[Docket No. FAA–2023–1055; Project Identifier AD–2023–00583–T; Amendment 39–22445; AD 2023–10–09]

Airworthiness Directives; The Boeing Company Airplanes

ACTION: Final rule; request for comments.

2023–10–09 The Boeing Company:
Amendment 39–22445; Docket No. FAA–2023–1055; Project Identifier AD–2023–00583–T.

Figure 1 to paragraph (g)(3)(i)—Allowable damage not extending beyond fastener hole width

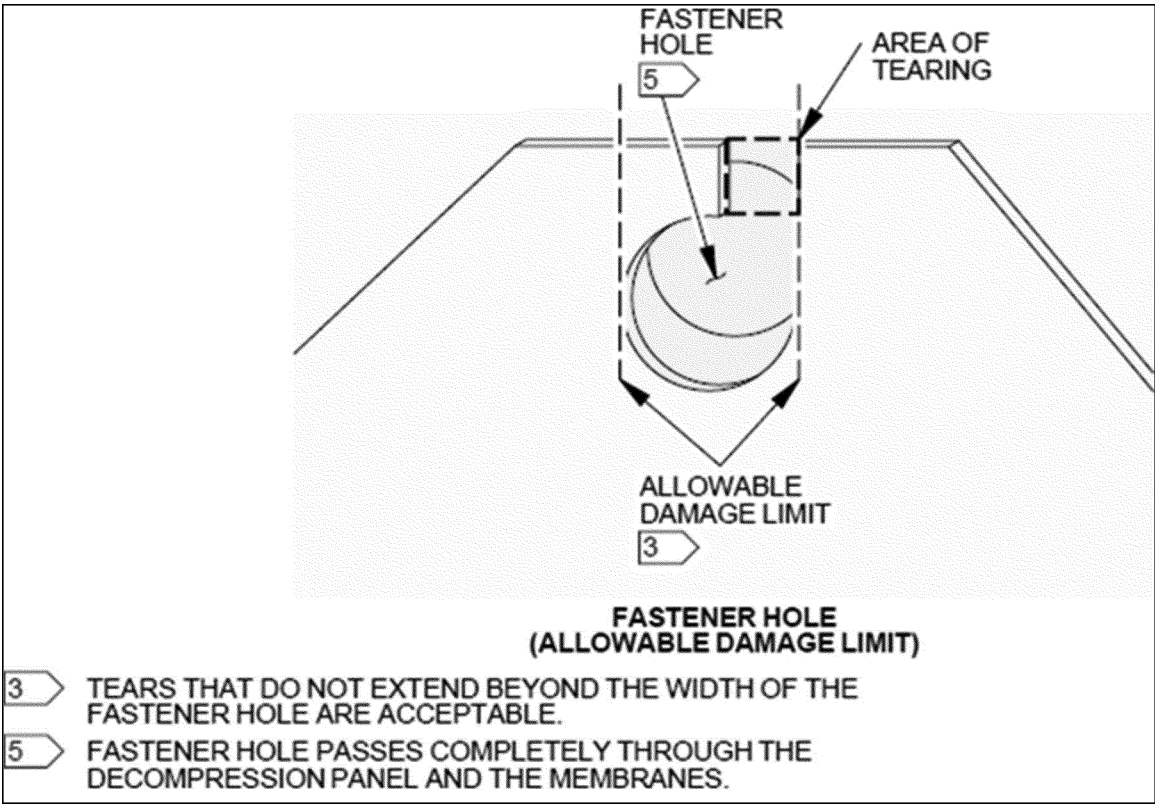
(i) If the damage is on the fastener hole, the damage must not extend beyond the width of the fastener hole. Refer to figure 1 to paragraph (g)(3)(i) of this AD. Where figure 1 to paragraph (g)(3)(i) of this AD refers to tears or tearing, this includes all types of damage as defined in paragraph (g)(2) of this AD.

Figure 2 to paragraph (g)(3)(ii)—Allowable damage not extending more than fastener hole diameter

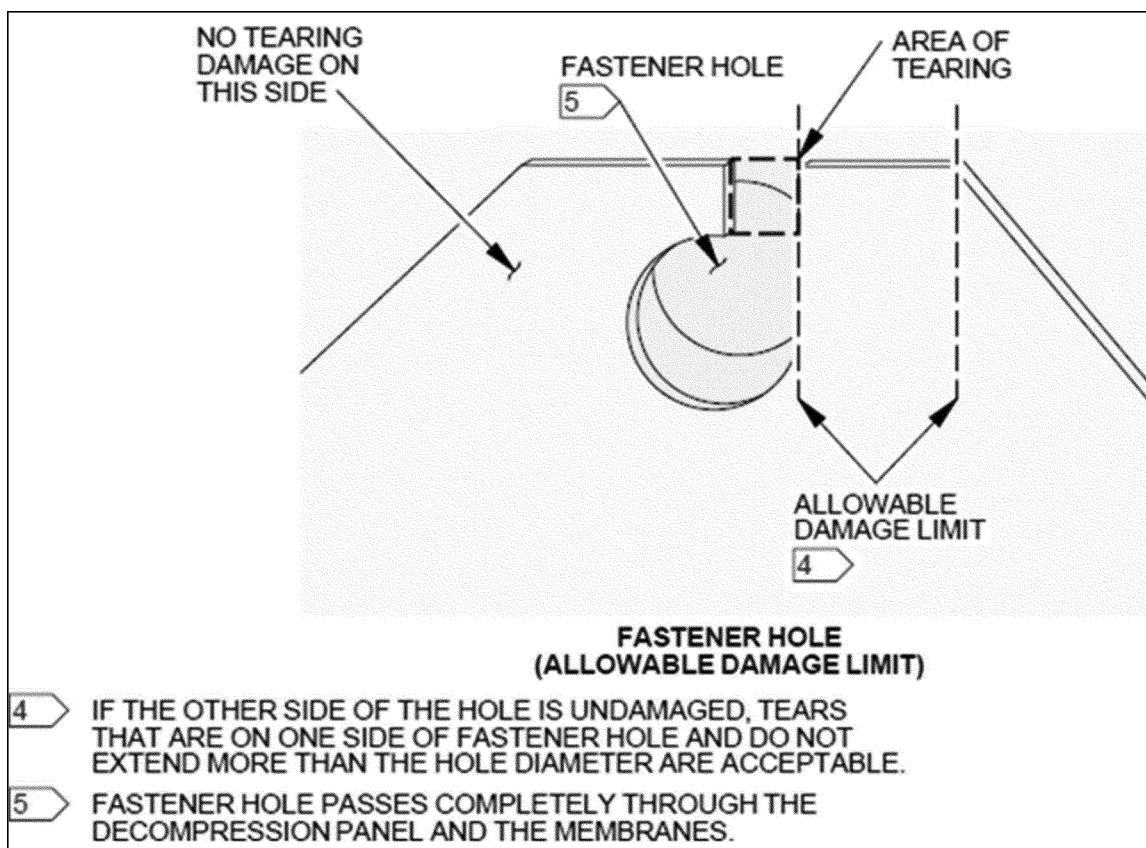
(ii) If the damage is on one side of the fastener hole and the other side of the fastener hole has no damage, the damage must not extend more than the diameter of

the fastener hole. Refer to figure 2 to paragraph (g)(3)(ii) of this AD. Where figure 2 to paragraph (g)(3)(ii) of this AD refers to tears, tearing, or tearing damage, this

includes all types of damage as defined in paragraph (g)(2) of this AD.
